# ST. PETERSBURG COLLEGE

## PALLADIUM BUILDING

### ADDENDUM NO. 1

MATRIX PROJECT NO. 16-0610

DRAWING NUMBER:  
**M2.1**

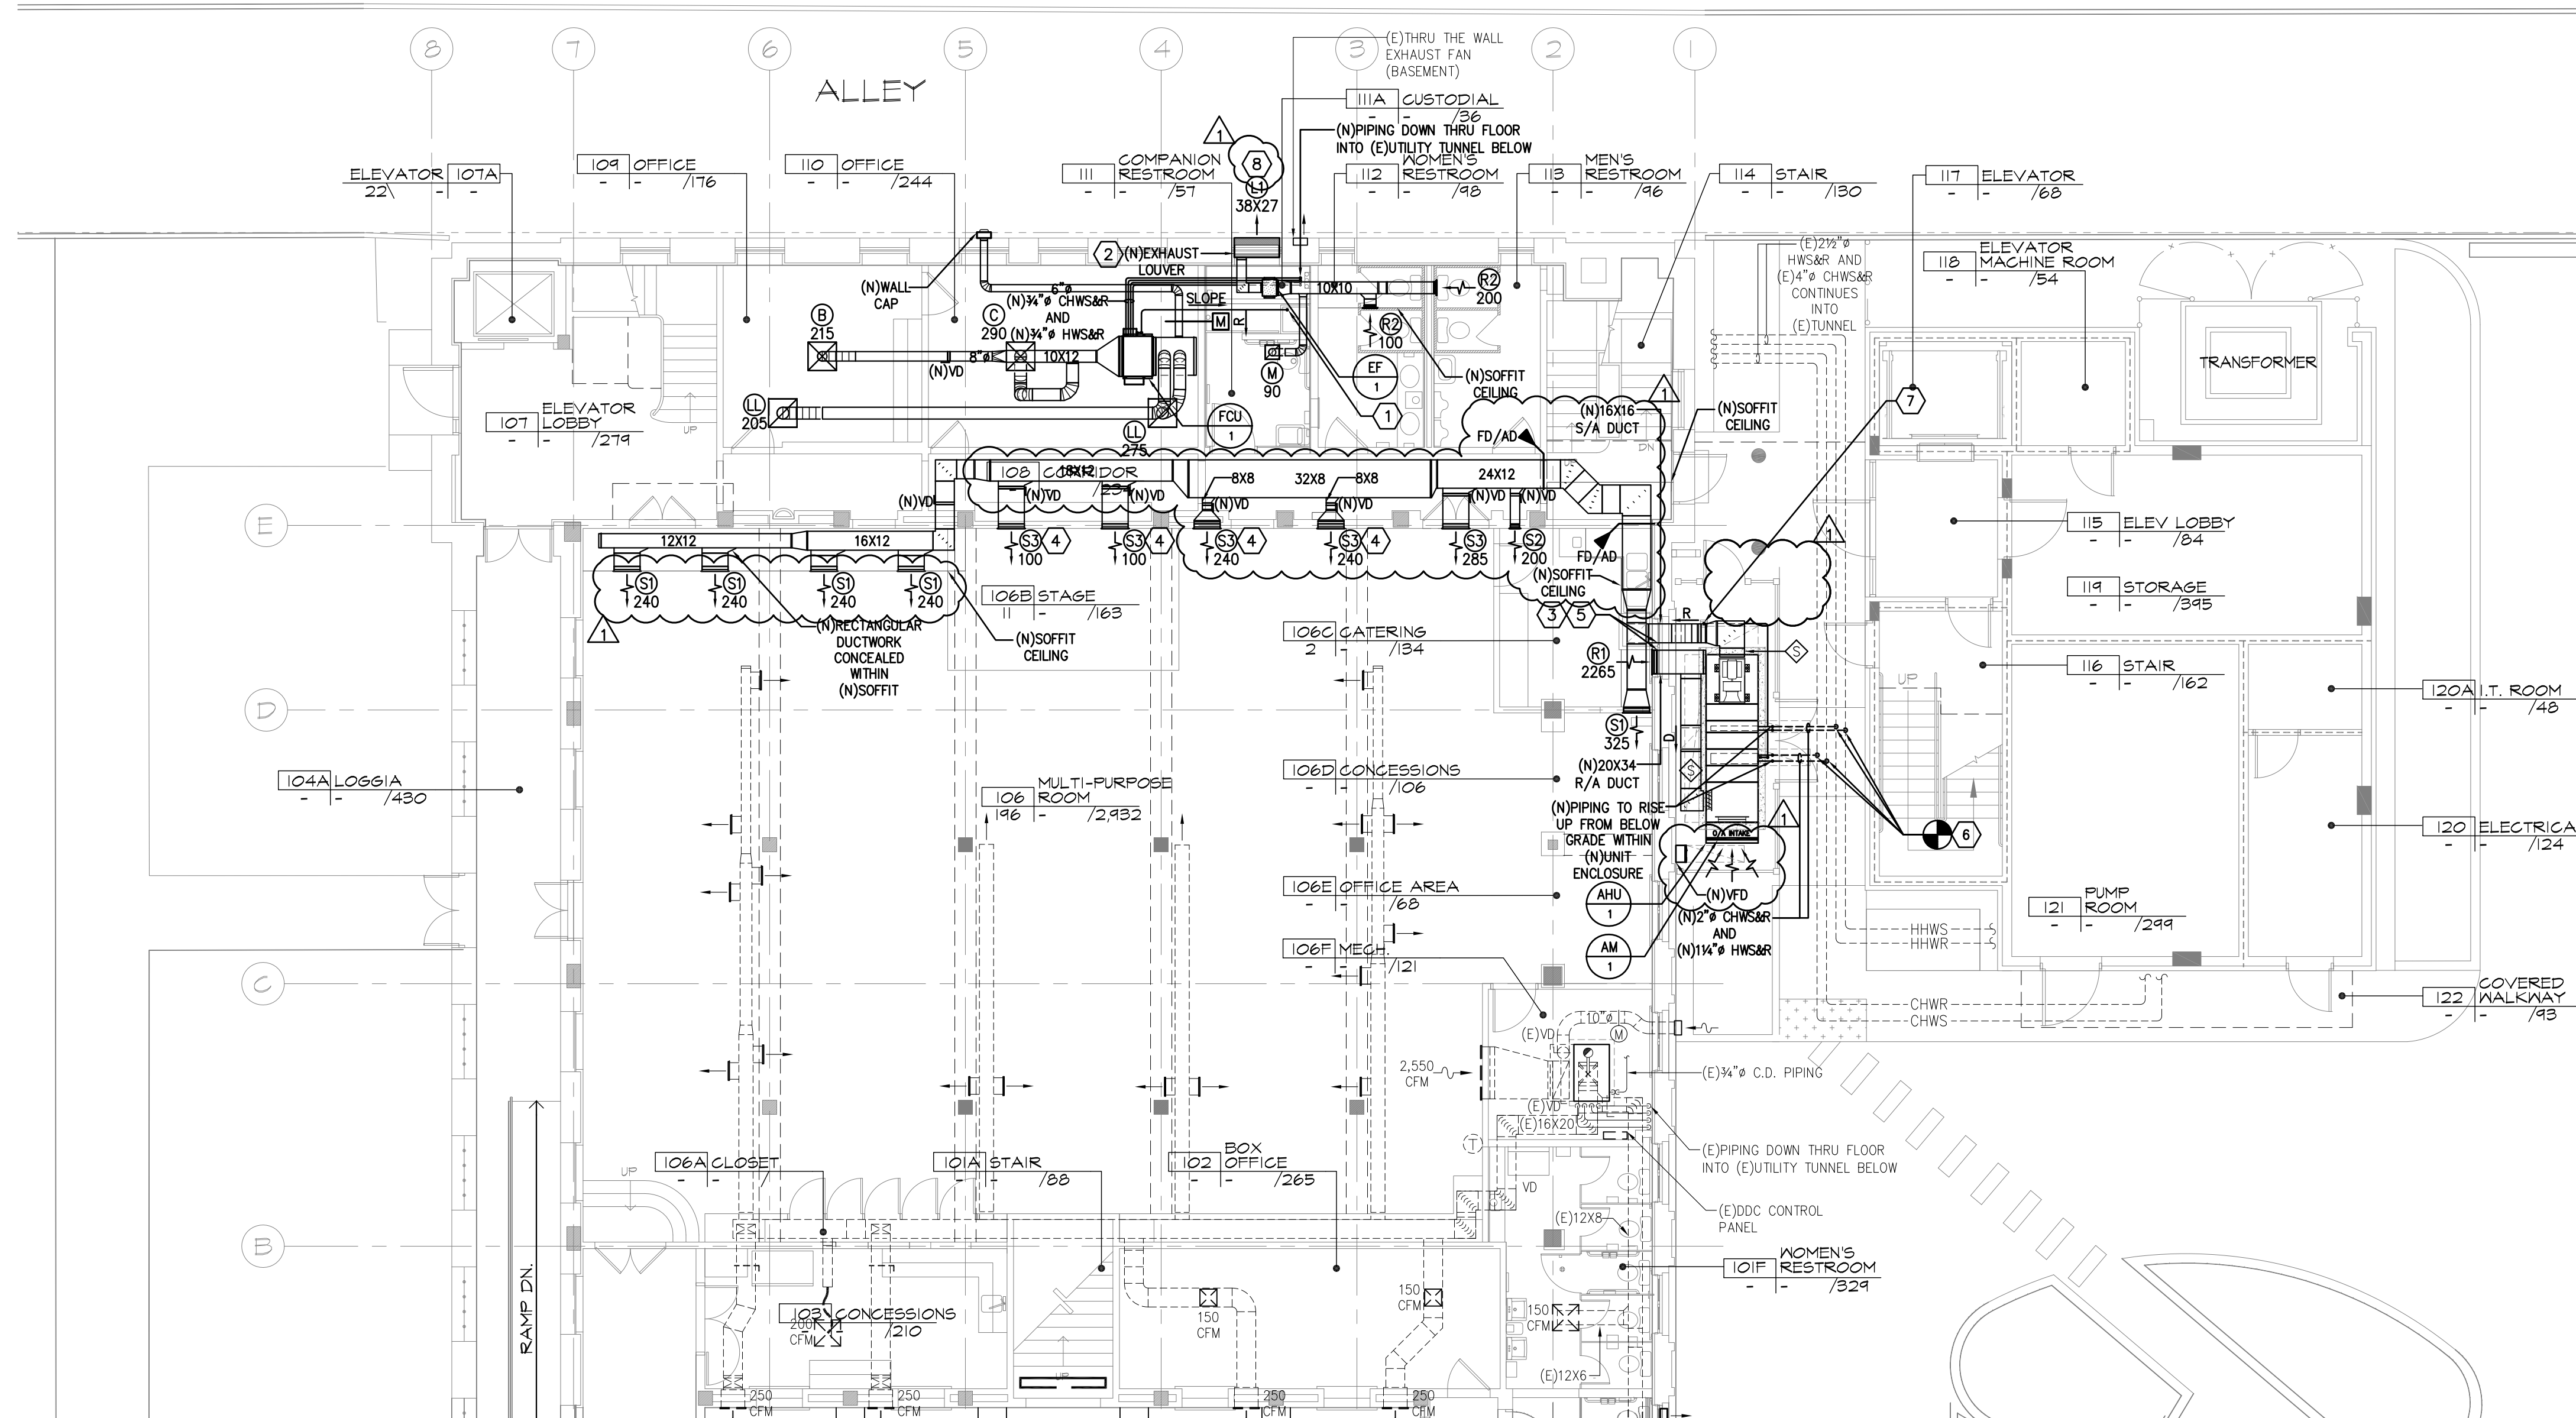
Item 4. Drawing M2.1, Partial Floor Plan - Mechanical

- MODIFIED the supply air duct sizes as shown.
- MODIFIED the quantity of new wall mounted supply air devices in the Stavros Room.
- MODIFIED the location of the AHU wall mounted exterior VFD.
- CLARIFIED the sizing scope intent of the exhaust louver of the north wall.
